# **AMD-K6<sup>®</sup>-2**

## **Processor Revision Guide**

### **Model 8**

Publication # <b>21641</b> Rev: <b>F</b> Amendment/ <b>0</b> Issue Date: <b>June 1999</b>
--

**Figure 1. AMD-K6<sup>®</sup>-2 Processor Assertion of HLDA Due to Simultaneous  $\overline{BOFF}$ /HOLD Assertion**

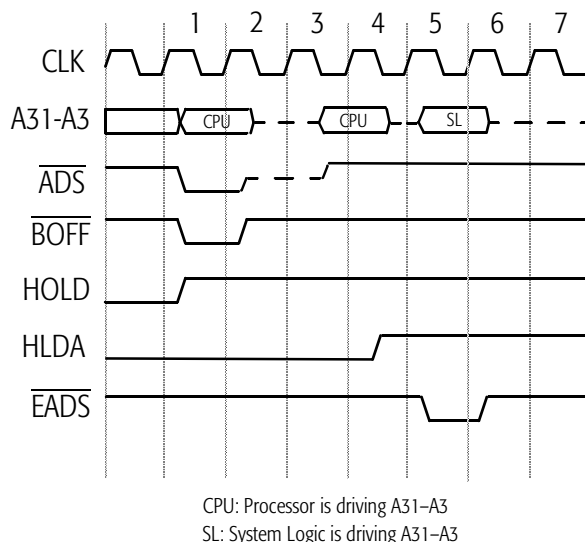
- If the system logic asserts  $\overline{\text{BOFF}}$  for a duration of one clock, anticipates the assertion of HLDA in clock 3 (see Figure 1)—which is the normal specified operation—and drives the address bus and  $\overline{\text{EADS}}$  for an inquire cycle in clock 3, then the processor will not sample  $\overline{\text{EADS}}$  asserted. In addition, address bus contention will occur in clock 3.

If the processor does not sample  $\overline{\text{EADS}}$  asserted during an inquire cycle, cache/memory incoherency will occur. Address bus contention can affect the reliability of the processor and the system logic.

**Suggested Workaround.** The system logic must sample the assertion of HLDA before asserting  $\overline{\text{EADS}}$  and driving the address bus for an inquire cycle—as shown in clock 5 of Figure 1.
